Access Compliance Report

Public Rights-of-Way

(Curb Ramps)

Intersection ID: 26202	Main Street: BALLANTRAE_VILLAGE_DR	Cross Street: SANDPIPER_DR	Location: SW
ADA ID: 839821C0F57A	Ramp Type: Perp	Initial Pass/Fail: Fail	Overall Compliance: No
Severity Score: 12.5			
Codes/Mitigation Info/Possible Solution		Field Measurements/Component Compliance

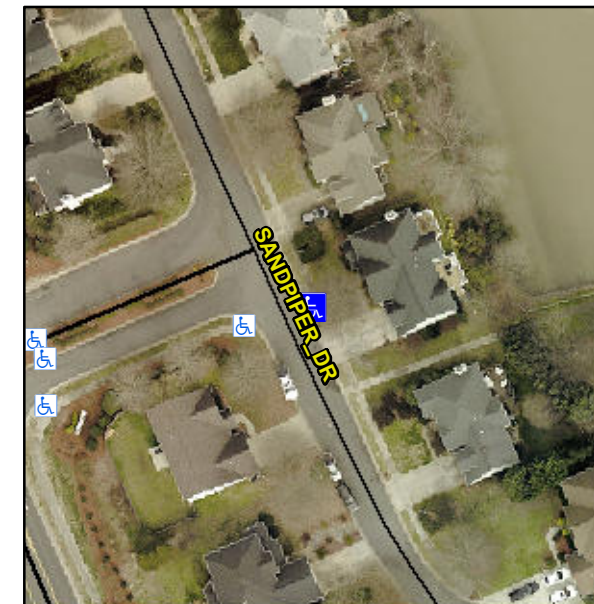
Not Found, R304.2.2

Compliance	Description	Data	Compliance	Description	Data
N/A	Ramp Length (in)	46.0	No	Ramp Slope (%)	9.7
Yes	Ramp Width (in)	106.0	Yes	Ramp XSlope (%)	1.9
N/A	Flare Type LT	N/A	N/A	Flare Type RT	N/A
N/A	Flare Slope LT (%)	N/A	N/A	Flare Slope RT (%)	N/A
N/A	Flare Traversable LT?	N/A	N/A	Flare Traversable RT?	N/A
N/A	Landing Length (in)	N/A	N/A	DWS Provided?	N/A
N/A	Landing Width (in)	N/A	N/A	DWS Contrast?	N/A
N/A	Landing Slope (%)	N/A	N/A	DWS Length (in)	N/A
N/A	Landing X Slope (%)	N/A	N/A	DWS Full Width?	N/A
N/A	Landing Curb? (Y/N)	N/A	N/A	DWS Offset (in)	N/A
N/A	Shared Landing?	N/A			
N/A	Gutter Ponding?	N/A	N/A	Gutter Slope (%)	N/A
N/A	Gutter Lip Ht (in)	N/A	N/A	Gutter X Slope (%)	N/A
N/A	Painted X Walk1?	No	N/A	Painted X Walk2?	N/A
	X Walk 1 Direction	To E		X Walk 2 Direction	N/A
N/A	X Walk 1 Width (in)	N/A	N/A	X Walk 2 Width (in)	N/A
	X Walk 1 Slope (%)	5.4		X Walk 2 Slope (%)	N/A
	X Walk 1 X Slope (%)	0.9		X Walk 2 X Slope (%)	N/A

Remove & Replace Entire Ramp.
